SAN LEANDRO UNIFIED SCHOOL DISTRICT
FACILITIES AND CONSTRUCTION – BOND DEPARTMENT

To: Facilities and Technology Committee Meeting on
Date: *10/30/19*
From: Bond Department
Date: *10/21/19*
Project Description: **Madison Elementary Classroom Wing Modernization**

Change Order

Project: **Madison Elementary Classroom Wing**
14751 Juniper Street
San Leandro, CA 94577

Subject: Restroom Tile

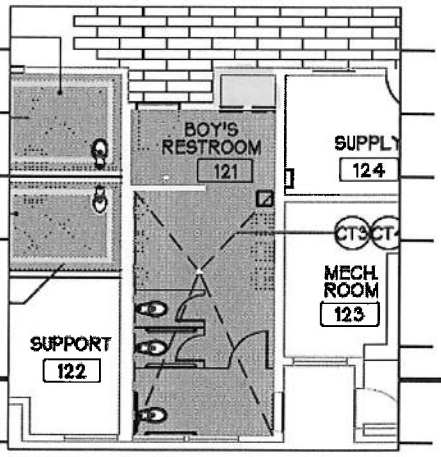
Description: The floor plans show a closet with no finishes in the Boys Restroom 121.

There is no closet in this space, so please confirm Rm 121 finishes will extend into this space.

Provide tile in closet. Adjust tile to accommodate tile.
